# SERVICE BULLETIN

M-870

April 15, 1983

## NEW VALVE GUIDES FOR XL SERIES TRANSMISSION MAINSHAFT SHIMS IGNITION MODULE/SENSOR CONNECTORS

Figure 1. Valve Guides and Collars

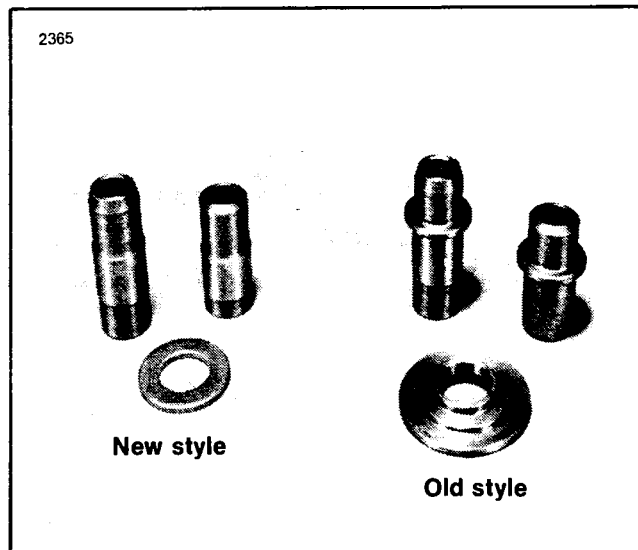
New style intake and exhaust valve guides, Figure 1, are being incorporated on the XL series 1000cc engines, beginning with crankcase number 783. New flat lower spring collars and new longer inner and outer springs are also being included at the same time. The longer springs provide increased spring tension.

The new style valve guides will also be used for service replacement of old style guides on all XL series 1000cc engines, and will allow the use of all old valve train components, if desired.

**The new lower spring collars and new longer springs can only be used with the new style valve guides.**

*To prevent possible mismatch of springs with old style valve guides and valve train components, the new springs are identified with red or orange paint on several coils.*

Figure 2. XL Shoulderless Valve Guide Driver

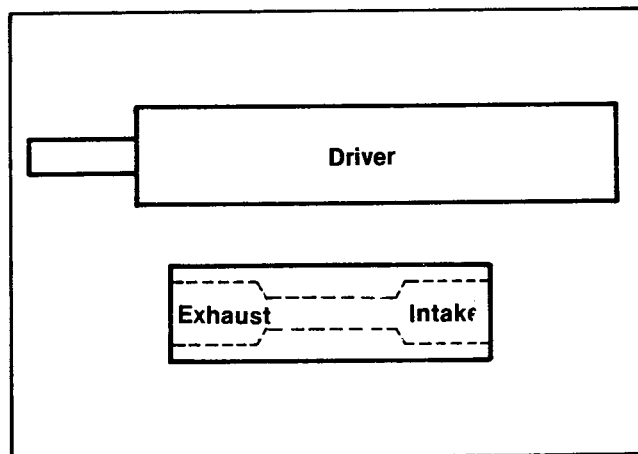
Because the new style valve guides do not have a shoulder, special VALVE GUIDE DRIVER HD-33871, Figure 2, must be used to control the guide installed height. See Figure 3.

Figure 4. Valve Train Components

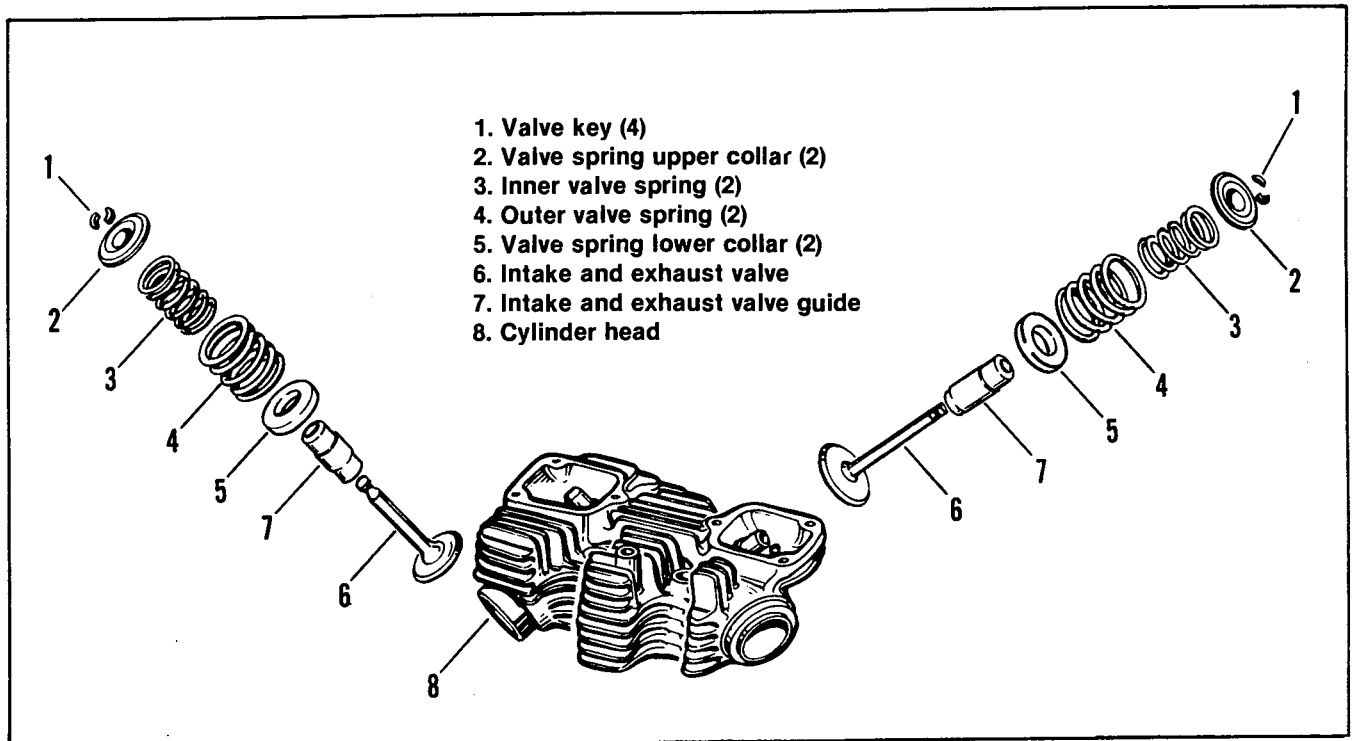
## PROCEDURE (Figure 4)

1. After removing the valve keys, valves, collars and springs, heat the cylinder head and drive the old valve guides from the head with a hammer and drift pin.
2. Install the new valve guides using VALVE GUIDE DRIVER HD-33871. Place the correct end of the tool over the guide and drive the guide into the head until the tool bottoms on the head.

*Remember, if you're using the new lower collar, then the new springs must be used. Also, if new springs are used, you must use the new lower collars.*

Figure 5. Mainshaft Thrust Washer

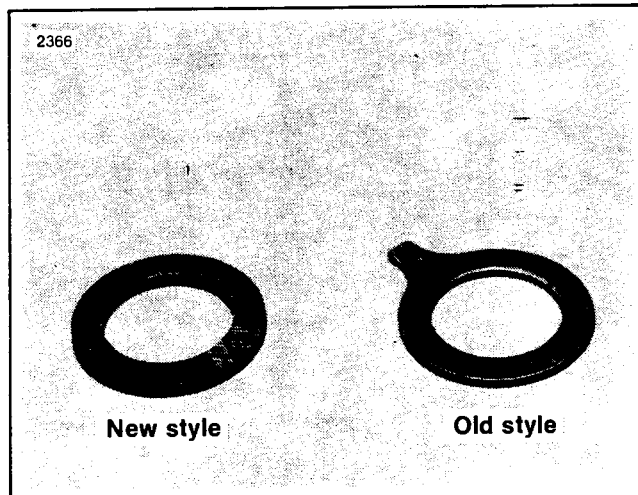
A production change, modifying the method of controlling transmission mainshaft end play, is being incorporated on late 1983 XL series machines. The new style thrust washer, Figure 5, is thicker than the old style thrust washer, allowing the use of one washer where two were previously required. Also the tang used to prevent full rotation of the washer has been eliminated as has been the rollpin in the crankcase, Figure 6.

The new thrust washers are available in four thicknesses; 0.098, 0.107 inch, 0.116 inch and 0.125 inch. A single new washer can replace the earlier style thrust washers if the end play is great enough to require the use of the new thicker washers.

The early style thrust washers (0.030 - 0.085 inch) with tangs will be available for service through Parts and Accessories for those early vehicles requiring thinner washers.

**Figure 7. Checking Mainshaft Endplay**

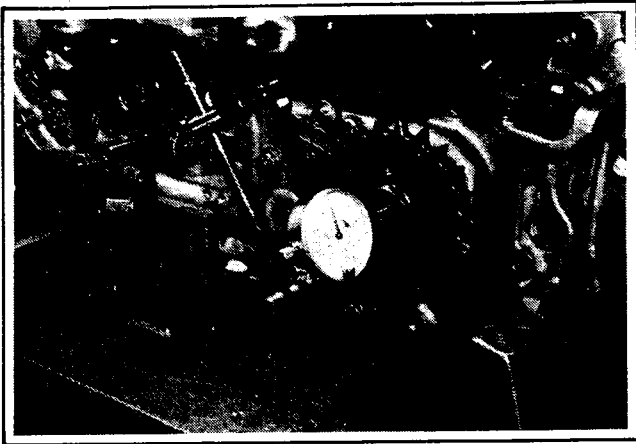
See Figure 7. The mainshaft end play limits remain the

same, 0.003 inch minimum with preload to 0.020 inch unloaded.

**Figure 8. Ignition Module/Sensor Connector Halves**

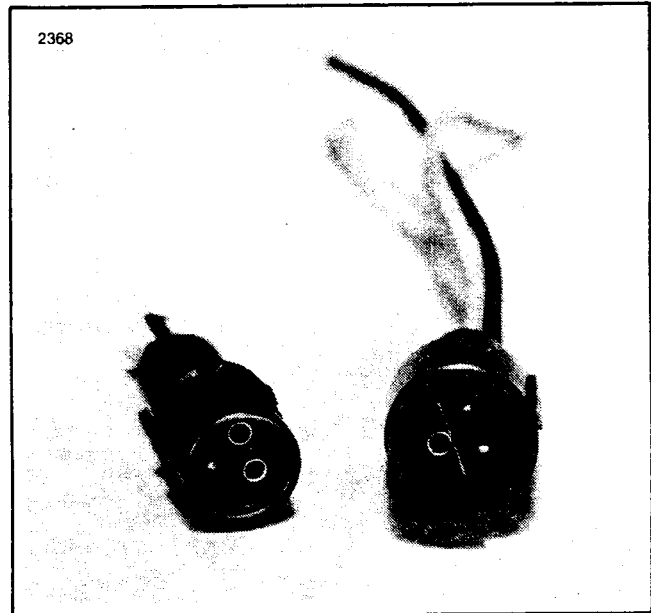
Late 1983 XL ignition modules Part No. 32410—84 and sensor assemblies Part No. 32400—80 are being manufactured with rubber rather than plastic connectors. This change is being made to improve component service life and to avoid possible separation of connectors in the field. When servicing early 1983 ignition systems, always check the module/sensor connectors for tight fit.

The late 1983 XL modules and sensors will interchange with the early 1983 XL modules and sensors, but will require replacement of the mating connector half if only one component is replaced. Rubber receptacles with 2 sockets and 1 pin or rubber plugs with 2 pins and 1 socket, (Figure 8) are available through Parts and Accessories.

*When servicing early 1983 XL ignition system components, always replace the ty wrap used to secure the module and sensor plastic connector halves.*
